**BRIDGEPORT WEST SEWER IMPROVEMENTS
SECTION C – LIFT STATION IMPROVEMENTS
CITY OF SIOUX CITY, IOWA
Project No. 6827C-539-201 – 2016**

ADDENDUM NO. 2

March 3, 2016

SHEET NO.
E.06

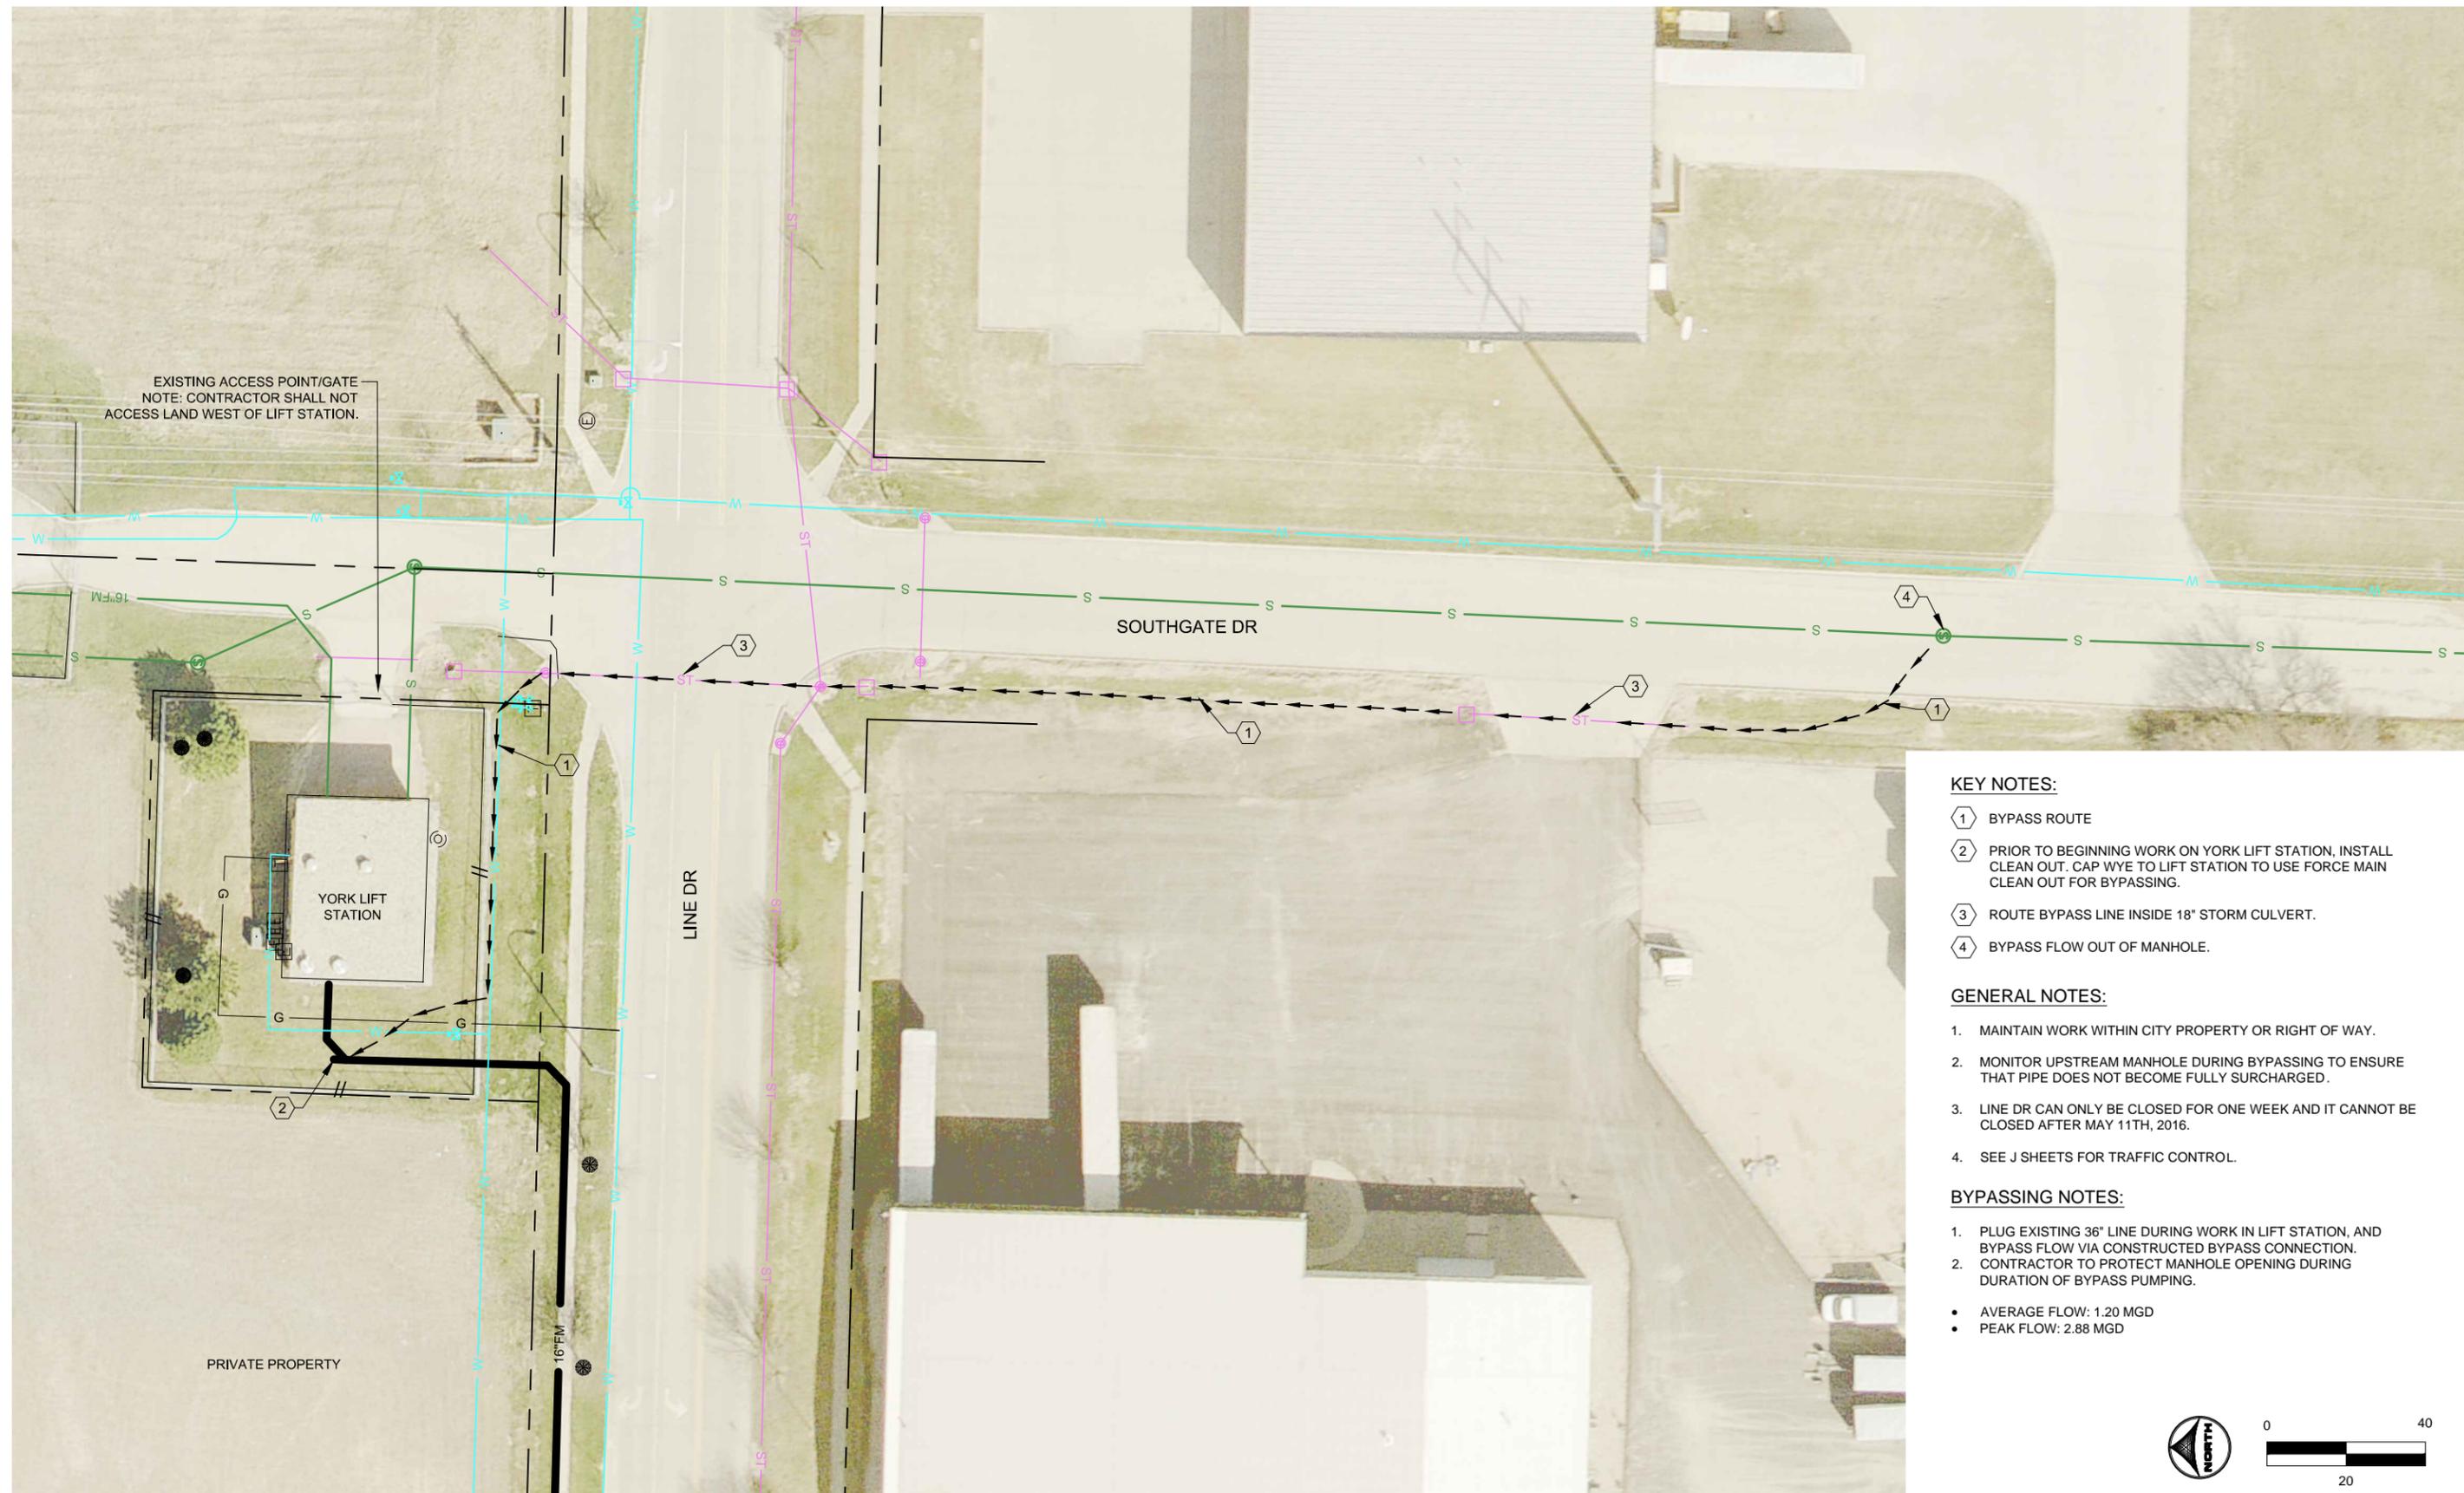
NO.	DATE	BY	REVISION DESCRIPTION
2	3/2/16	JV	ADJUST CORE DRILL LOCATIONS, SHOW EXISTING HATCH

SHEET NO.
J.01

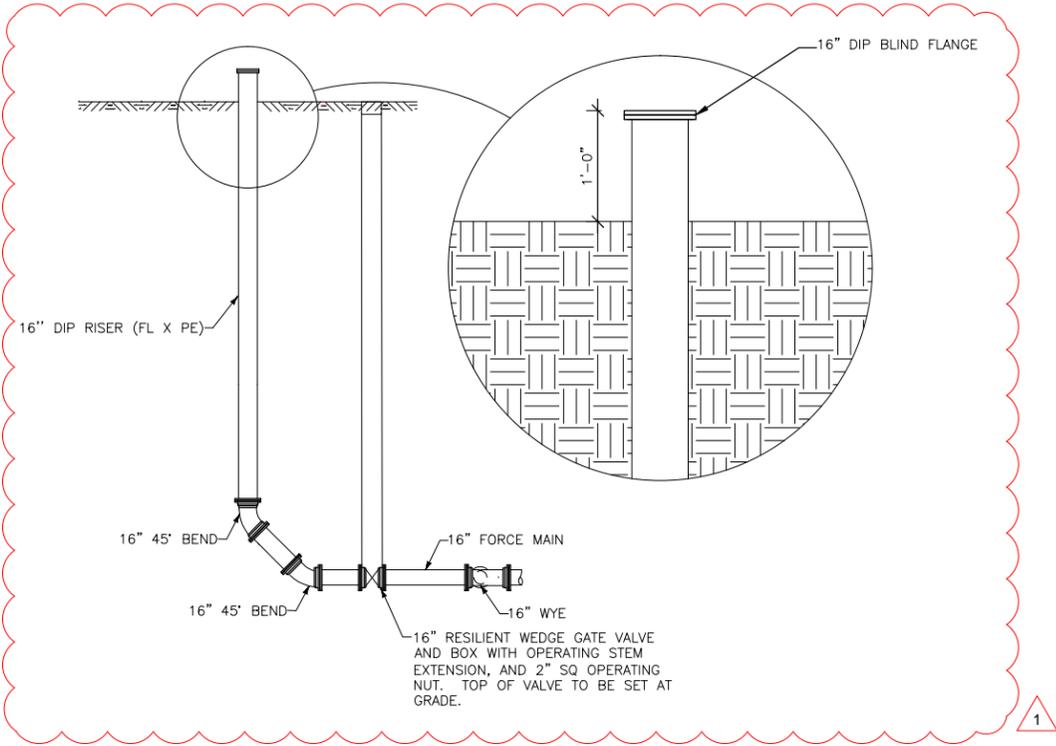
NO.	DATE	BY	REVISION DESCRIPTION
2	3/2/16	JV	CHANGE DETOUR ROUTE TO STADIUM DR, NOTE 1

SHEET NO.
U.16

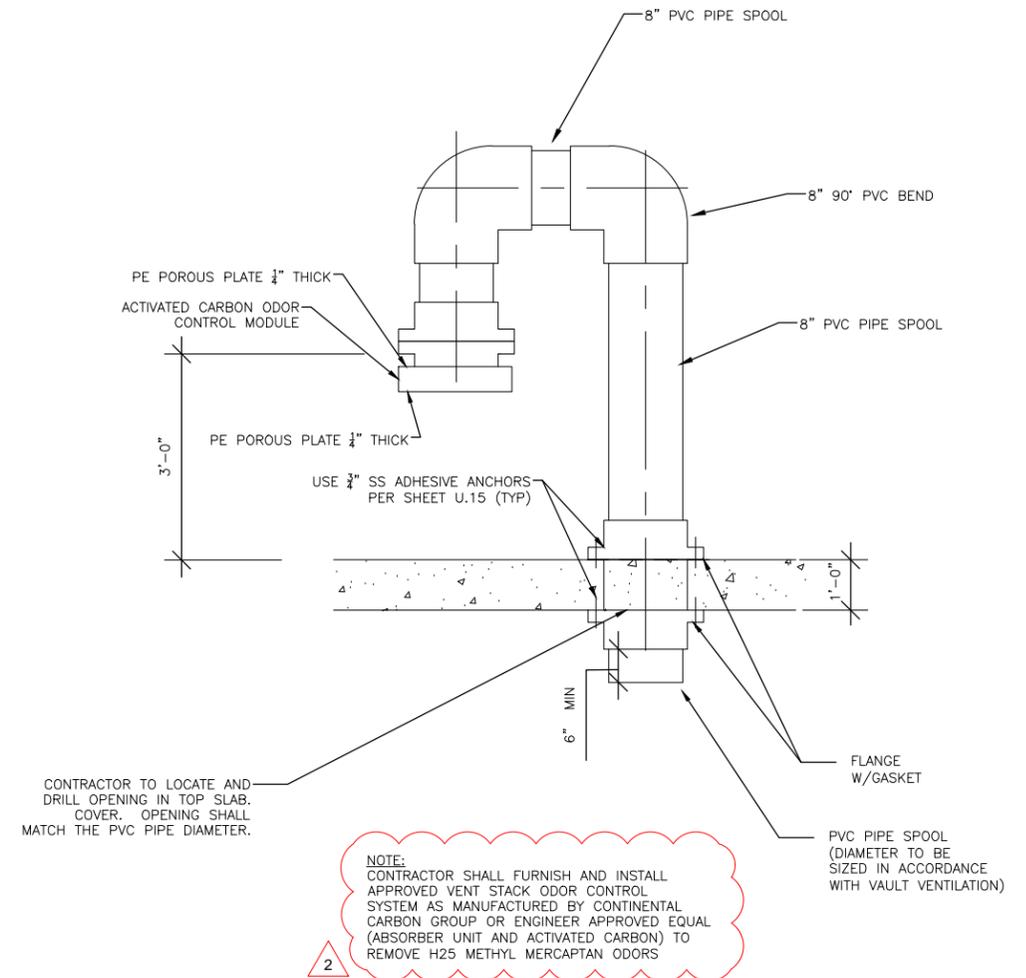
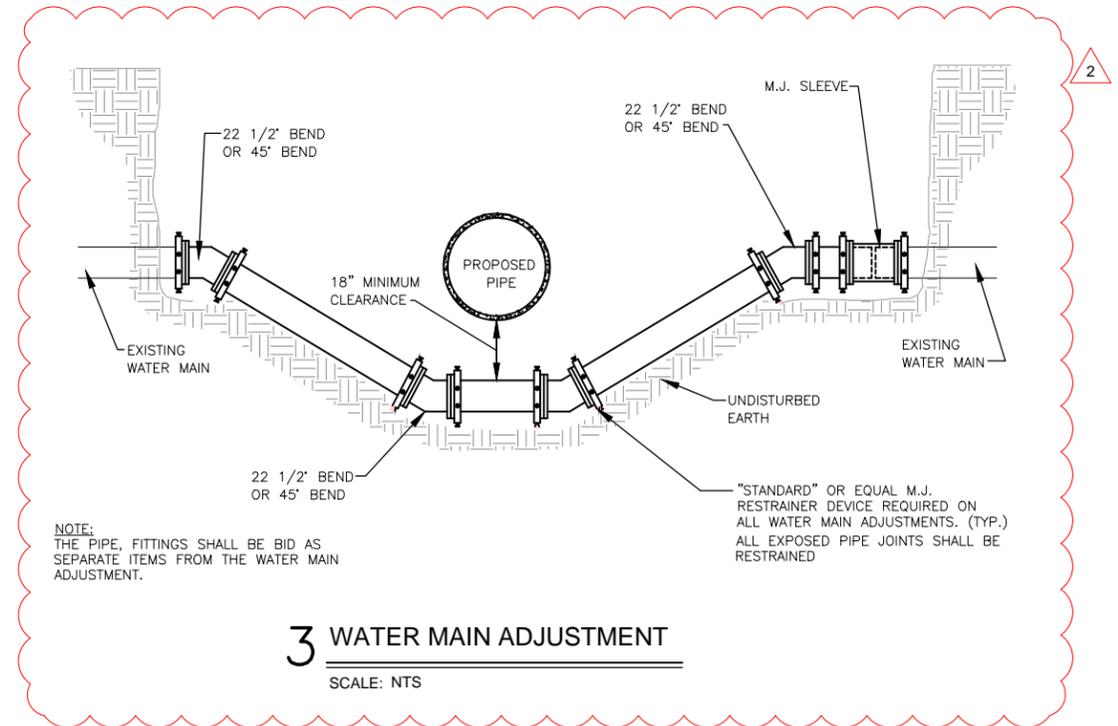
NO.	DATE	BY	REVISION DESCRIPTION
1	2/22/16	JV	REVISE CLEANOUT DETAIL
2	3/2/2016	JV	ADD WATER MAIN ADJUSTMENT DETAIL
